CHANGE TYPE: Modification

CHANGE SUMMARY: Unless laminated glass is used, structural glass baluster panels in guards now require an attached top rail or handrail.

R308.4.4

Glazing in Guards and Railings

Prohibited Hazardous Glazing Locations at Bottom Stair Landings

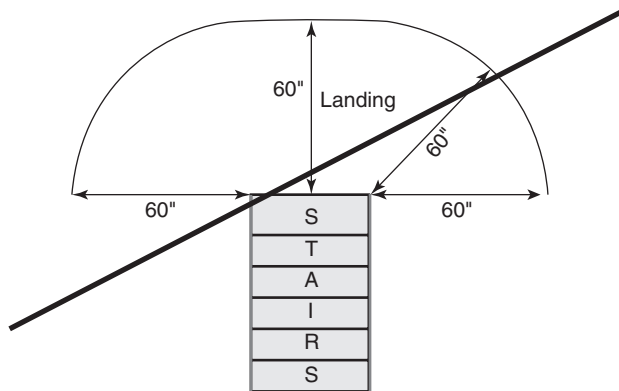
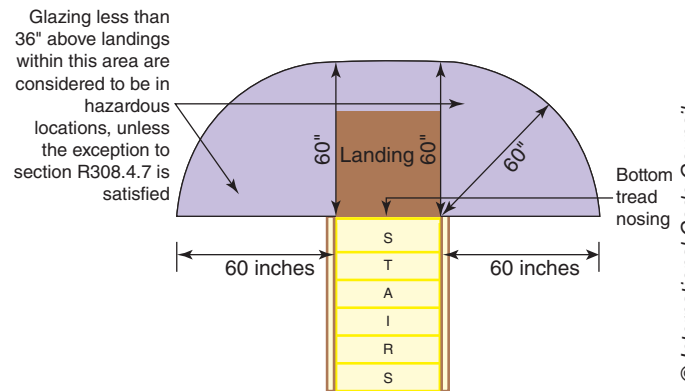
CHANGE SUMMARY: Figure R308.4.7 has been replaced with a new figure and the caption modified to more accurately reflect the related code provision.

CHANGE SIGNIFICANCE: In defining the hazardous location for glazing at the bottom stair landing, the 2015 IRC added a figure and clarified that the area of concern was beyond the plane of the bottom stair nosing. The hazard of falling into glazing occurs in the bottom landing area in front of and to either side of the direction of travel, and that was reflected in the previous change. The revised text in the 2015 edition was accompanied by a new figure that was helpful to code users in visualizing the requirement. However, the caption to the figure was misleading in that it described the area shown in the figure as prohibited glazing locations. The change to the figure caption in the 2018 IRC correctly identifies the illustrated area as a location considered hazardous related to the installation of glazing. Where glazing is installed in a hazardous location, safety glazing is required. The figure has also been updated for the 2018 edition by adding labels to better identify the area under consideration and to duplicate the corresponding requirements of the code text.

2018 CODE: R308.4.7 Glazing adjacent to the bottom stair landing. Glazing adjacent to the landing at the bottom of a stairway where the glazing is less than 36 inches (914 mm) above the landing and within a 60-inch (1524 mm) horizontal arc less than 180 degrees from the bottom tread nosing shall be considered to be a hazardous location.

Exception: Where the glazing is protected by a guard complying with Section R312 and the plane of the glass is more than 18 inches (457 mm) from the guard.

Drainage airspace behind veneer

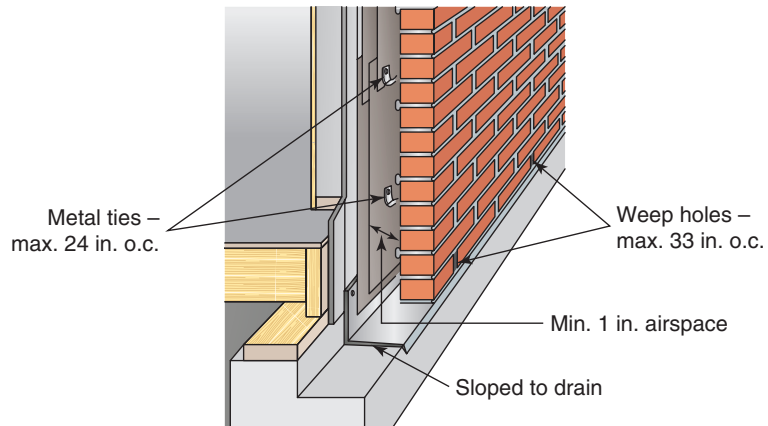
CHANGE SUMMARY: The new footnote “c” in Table R703.8.4(1) allows drainage airspace to contain some mortar spills.

CHANGE SIGNIFICANCE: The new footnote “c” in Table R703.8.4(1) acknowledges that the required airspace behind brick veneer will never be completely devoid of mortar. Some spillage of mortar occurs as part of the installation. The air space, along with the water-resistant barrier, flashing and weep holes, provides a drainage system to keep the backing and stud walls dry and direct water to the exterior surface. Historically, architects, engineers, code officials and building owners have recognized the difference between brick veneer with a code-compliant airspace with limited amounts of mortar spillage and one that is blocked by mortar. However, veneer airspace previously deemed acceptable has been incorrectly called into question during litigation after the building has been occupied and is experiencing water damage or drainage issues not associated with the brick veneer system. This clarification explicitly acknowledges that the airspace may contain some mortar from construction as long as the airspace provides drainage.

c. An airspace that provides drainage shall be permitted to contain mortar from construction.
